Docket Item #9

SUBDIVISION #2007-0002

Planning Commission Meeting
June 5, 2007

ISSUE: Consideration of a request to subdivide the subject property into two lots.

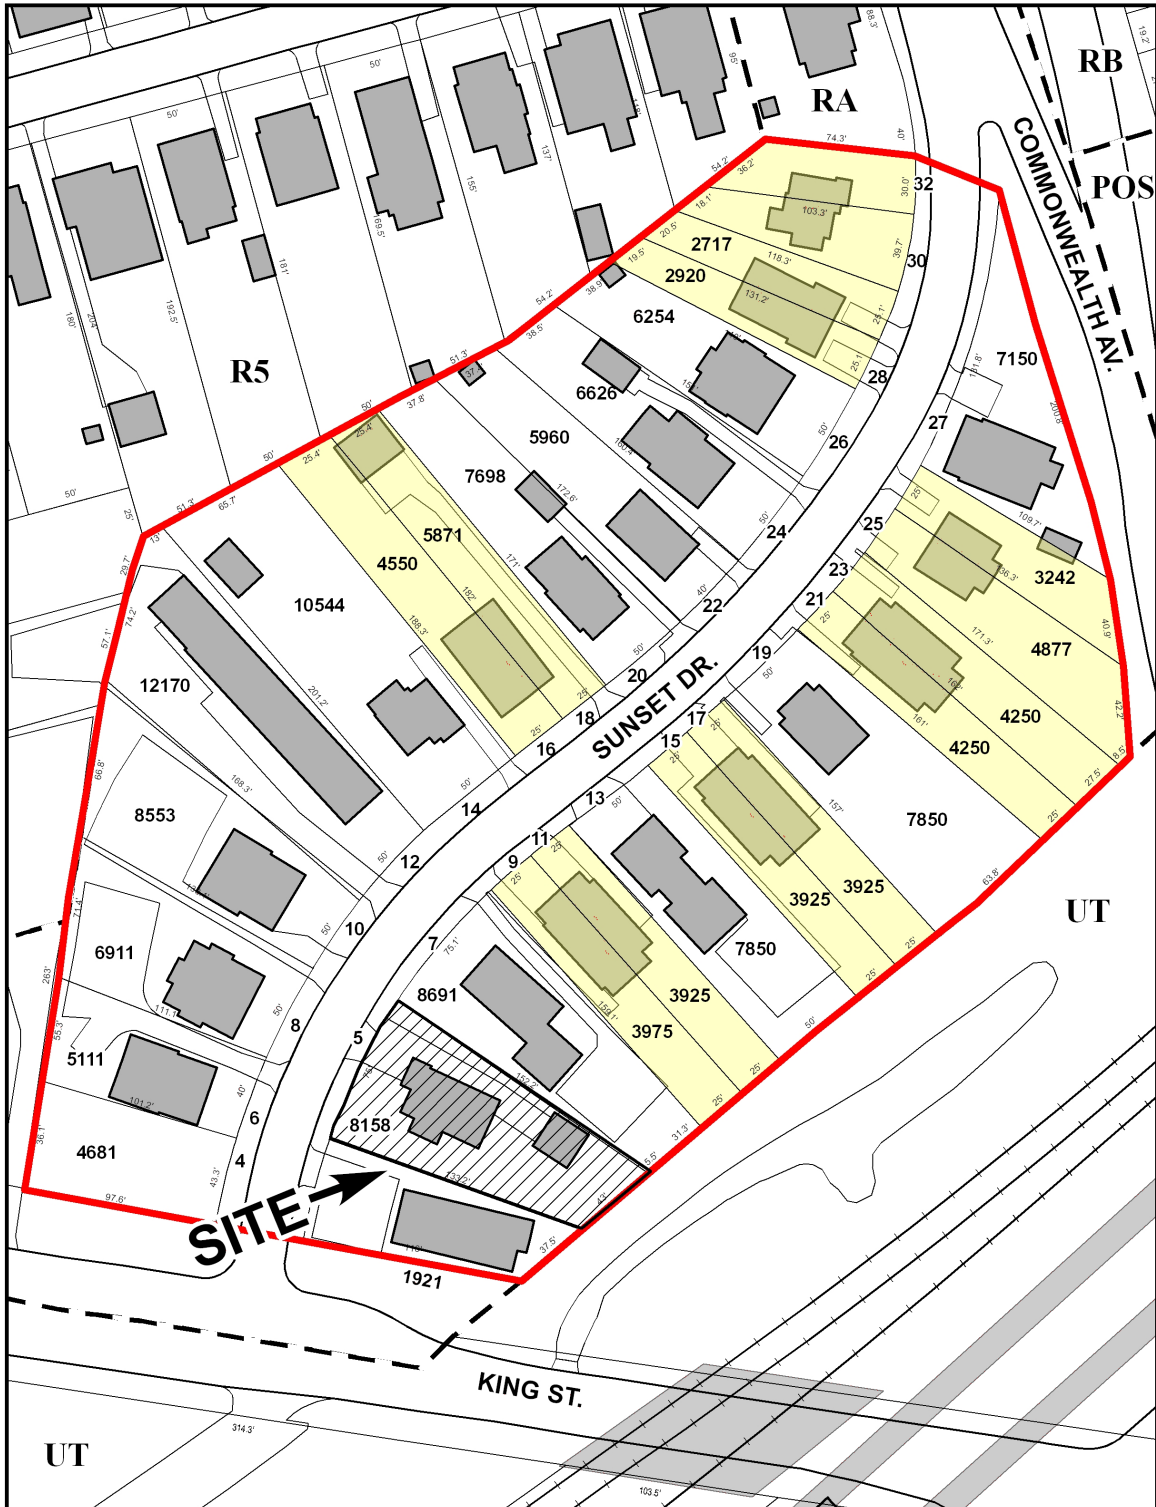
The applicant proposes to subdivide the property into two lots. The proposed lots will contain 4,256 square feet and 3,902 square feet. The applicant proposes to demolish the existing single family home and build a two-family, semi-detached house on the proposed lots (See attached plat). The applicant's plans call for the preservation of the existing trees. There is a utility pole located at the southern end of the site.

Access to the subject property is from an existing curb-cut that is located on Sunset Drive. With the proposed subdivision an additional curb cut will be required. This will necessitate the filing of a curb cut application with the Department of Transportation and Environmental Services. The applicant proposes to decrease the width of the existing curb cut from 30 feet to 10 feet and create another 10 foot curb cut at the southern edge of lot 510. Transportation and Environmental Services has indicated support for the proposed curb cut if the applicant agrees to relocate the utility pole currently at the southern end of the lot. The applicant has agreed to incur the cost of relocating the existing utility pole.

1. The final subdivision plat shall comply with the requirements of Section 11-1700 of the Zoning Ordinance. (P&Z)
2. Locations of all easements and reservations shall be depicted on the final subdivision plan. (P&Z)

3. The final plat shall include the Surveyors Certification and plat title to indicate resubdivision of the existing lots. (P&Z)
4. The Applicant shall be responsible for the relocation of the existing utility pole in front of 5 Sunset Drive. (P&Z)
